**Planning & Development Division**  
*Planning & Economic Development Department*

<b>File Number</b>	PL 22-146	<b>Contact</b>	Chris Lee, clee@duluthmn.gov	
<b>Type</b>	Variance – required driveway locations	<b>Planning Commission Date</b>	September 13, 2022	
<b>Deadline for Action</b>	<b>Application Date</b>	August 11, 2022	<b>60 Days</b>	October 10, 2022
	<b>Date Extension Letter Mailed</b>	August 19, 2022	<b>120 Days</b>	December 9, 2022
<b>Location of Subject</b>	925 East 4 <sup>th</sup> Street			
<b>Applicant</b>	Lunar Legacy, LLC	<b>Contact</b>	David Nelson	
<b>Agent</b>	Heirloom Property Management	<b>Contact</b>		
<b>Legal Description</b>	PIN: 010-3830-15150, 010-3830-15090, 010-3830-15070, 010-3830-15050,			
<b>Site Visit Date</b>	September 1, 2022	<b>Sign Notice Date</b>	August 30, 2022	
<b>Neighbor Letter Date</b>	August 31, 2022	<b>Number of Letters Sent</b>	73

**Proposal**

PL22-146  
Variance  
925 E 4th St

ALL SHOWN FLOOR TO FLOOR HEIGHTS AT 10'-6", EXCEPT AT LEVEL 2 AT 11'-6" FOR AMENITY DECK ROOF DROP, FOR 55' BUILDING HEIGHT TO PARAPET FROM AVERAGE GRADE PLANE. TOWER NIC IN BUILDING HEIGHT FROM AVERAGE GRADE PLANE

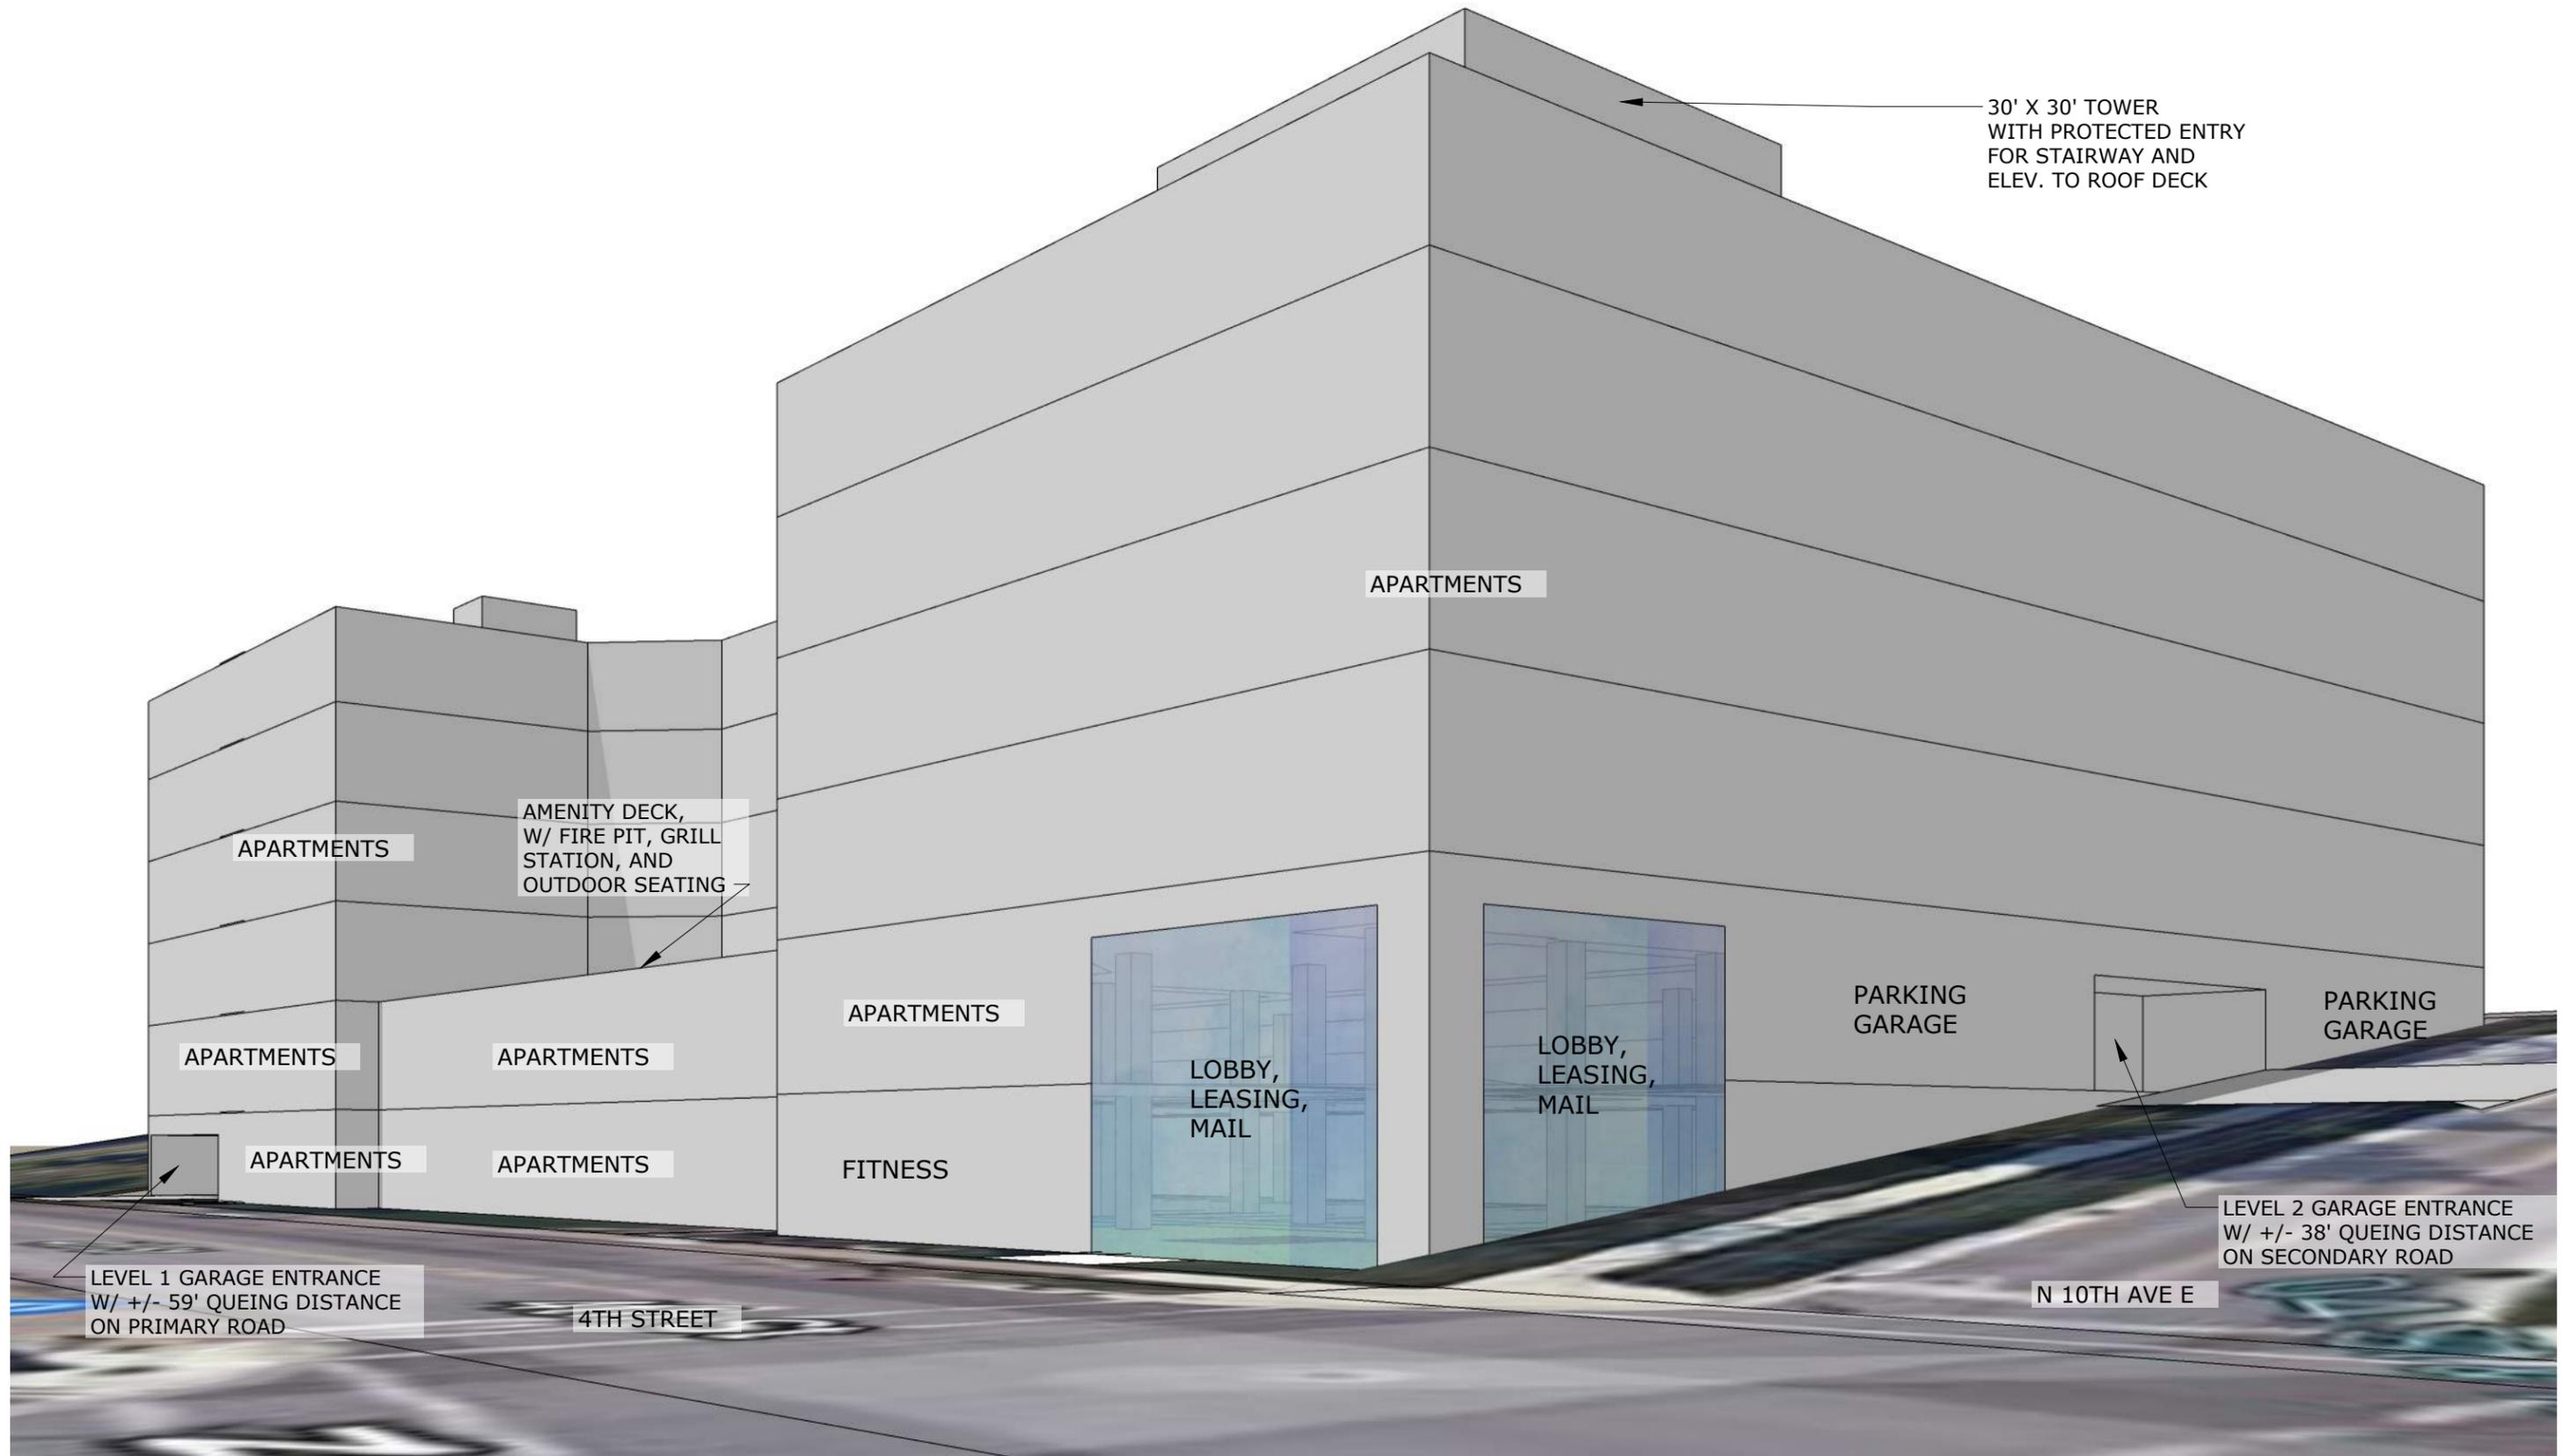
1. Applicant is proposing to construct a 6-story multifamily structure with 121 residential units and 97 covered parking stalls.
2. In F-6, a Corridor II Building is required to have parking access from the alley when the alley is present. The applicant is proposing to have one driveway on East 4<sup>th</sup> St. and one on 10<sup>th</sup> Ave E.

3. The applicant states that the extreme topography makes it difficult to have a single driveway from the alley that can access two floors of parking. The slope on the subject property is 14 degrees from 4<sup>th</sup> St. to alley.

10. St Louis County. Public Works, as the controlling agency of this stretch of 4<sup>th</sup> Street, has approved an additional driveway.
11. The variance, if granted, will not increase fire danger as the Fire Department possesses equipment for fighting fires on structures of this size and larger.

12. Granting the variance is not expected to unreasonably diminish established property values in the area.
13. Granting the variance is not expected to impair the health, safety, or public welfare of inhabitants of the city due to factors identified above. The applicant is proposing a pedestrian warning system on E 4<sup>th</sup> St.

Based on the above findings, Staff recommends that Planning Commission grant the variance to allow a height of up to 40 feet for the properties listed in the legal description above, with the following conditions:

- 1) The project be limited to, constructed, and maintained based on the plans submitted with the application that shows the locations of the driveways.
- 2) A pedestrian warning system is installed to warn sidewalk users a vehicle is approaching.
- 3) Any alterations to the approved plans that do not alter major elements of the plan may be approved by the Land Use Supervisor without further Planning Commission; however, no such administration approval shall constitute a variance from the provisions of Chapter 50.
